# TIB 43-069: DPF Regeneration Two-Position Switch Parameter Update

DPF Regeneration Two-Position Switch Parameter Update

A DPF regeneration two-position switch parameter is causing inhibited DPF regeneration. A parameter update, via Cummins Insite, restores proper DPF regeneration function.

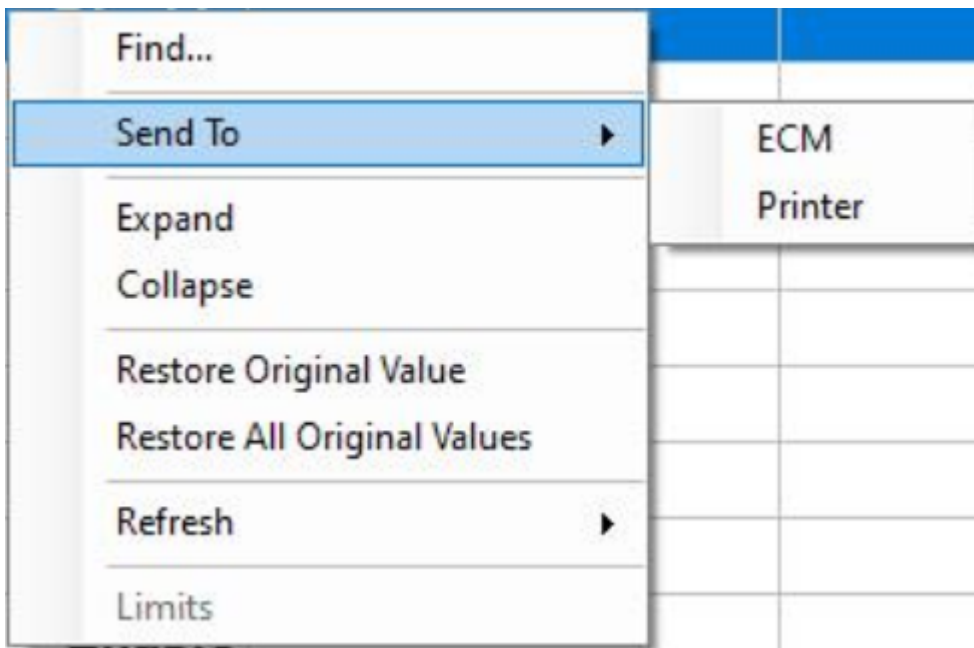
1. Connect to the truck with Cummins Insite.
2. Select **Features and Parameters** and locate the parameter named *Diesel Particulate Filter Regeneration Permit Switch*.

3. Set the status to **Disable**.

4. Right-click **Send To** and select **ECM**.

5. Follow the prompts to make sure the ECM value is successfully changed.
6. Confirm there are no faults.
7. Close Insite and disconnect from the truck.
